Access Compliance Report

Public Rights-of-Way

Intersection ID: 48304	Main Street: FAZENDA_DR	Cross Street: GANSO_LN	Location: NW
ADA ID: 46B88010A4A9	Ramp Type: PerpDiag	Initial Pass/Fail: Fail	Overall Compliance: No
Severity Score: 8.75			
Codes/Mitigation Info/Possible Solution		Field Measurements/Component Compliance

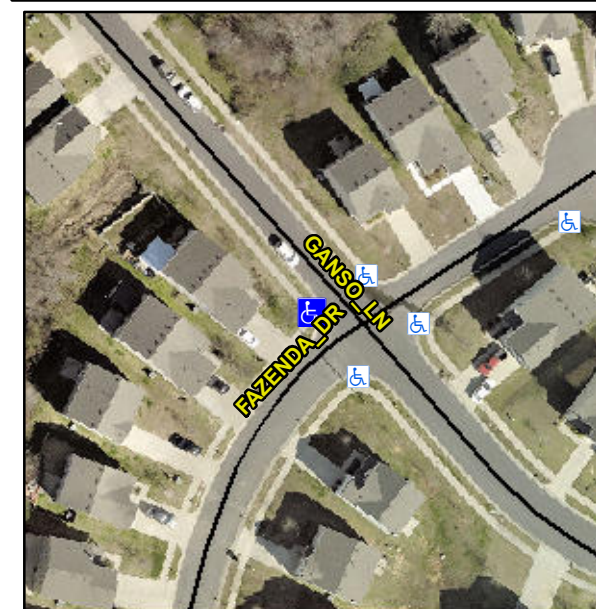
Not Found, R304.5.1

Compliance	Description	Data	Compliance	Description	Data
N/A	Ramp Length (in)	48.0	Yes	Ramp Slope (%)	8.0
No	Ramp Width (in)	47.0	Yes	Ramp XSlope (%)	1.3
N/A	Flare Type LT	N/A	N/A	Flare Type RT	N/A
N/A	Flare Slope LT (%)	N/A	N/A	Flare Slope RT (%)	N/A
N/A	Flare Traversable LT?	N/A	N/A	Flare Traversable RT?	N/A
N/A	Landing Length (in)	N/A	N/A	DWS Provided?	N/A
N/A	Landing Width (in)	N/A	N/A	DWS Contrast?	N/A
N/A	Landing Slope (%)	N/A	N/A	DWS Length (in)	N/A
N/A	Landing X Slope (%)	N/A	N/A	DWS Full Width?	N/A
N/A	Landing Curb? (Y/N)	N/A	N/A	DWS Offset (in)	N/A
N/A	Shared Landing?	N/A			
N/A	Gutter Ponding?	N/A	N/A	Gutter Slope (%)	N/A
N/A	Gutter Lip Ht (in)	N/A	N/A	Gutter X Slope (%)	N/A
N/A	Painted X Walk1?	No	N/A	Painted X Walk2?	No
	X Walk 1 Direction	To S		X Walk 2 Direction	To E
N/A	X Walk 1 Width (in)	N/A	N/A	X Walk 2 Width (in)	N/A
	X Walk 1 Slope (%)	8.4		X Walk 2 Slope (%)	3.8
	X Walk 1 X Slope (%)	3.7		X Walk 2 X Slope (%)	6.9

Remove & Replace Curb Ramp With Two New Directional Ramps or Equivalent.
